Project: St. Bernard Parish – Public Library
Judge Perez Drive
St. Bernard Parish, LA
Parish Project No. SBPG/NPL
ABM Project No. 201803
MBA Project No. 11884

Subject: REQUEST FOR INFORMATION

RFI Number: 96
RFI Title: Teen Room Receptacle & Data Elevation

FLOOR PLAN - POWER & SPECIAL SYSTEMS

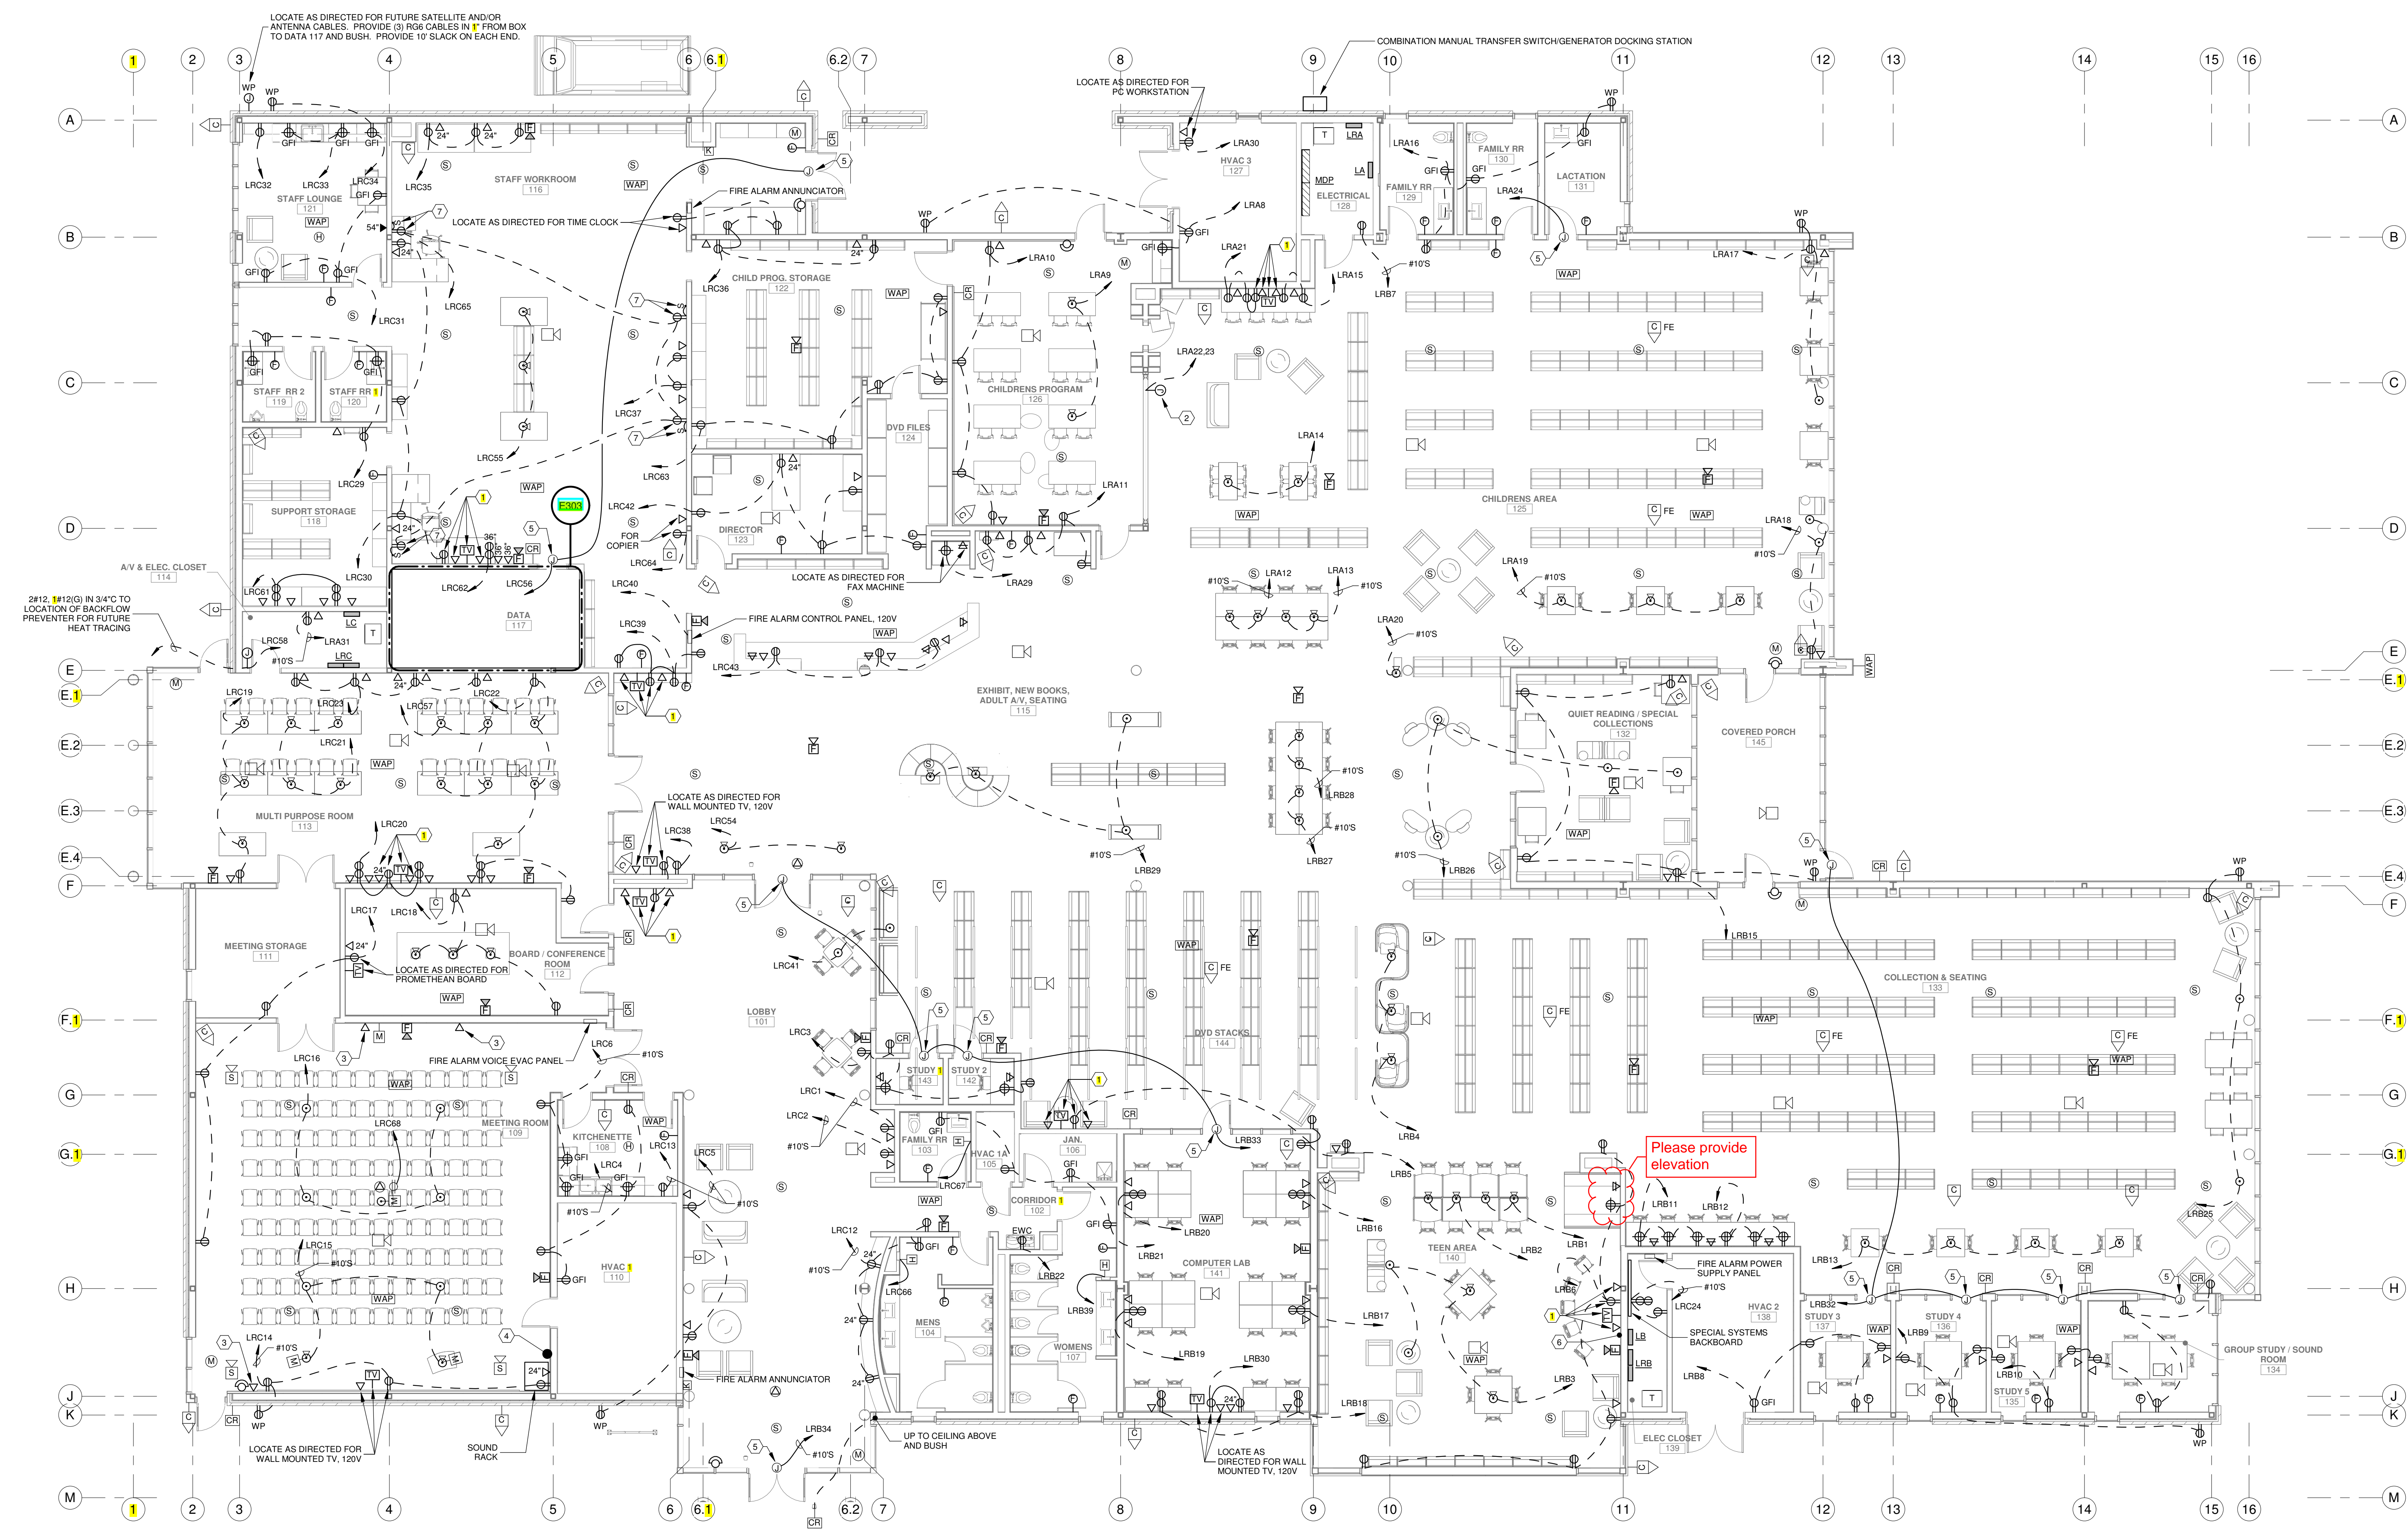
Please provide an elevation for the clouded data and the receptacle located in the team room.
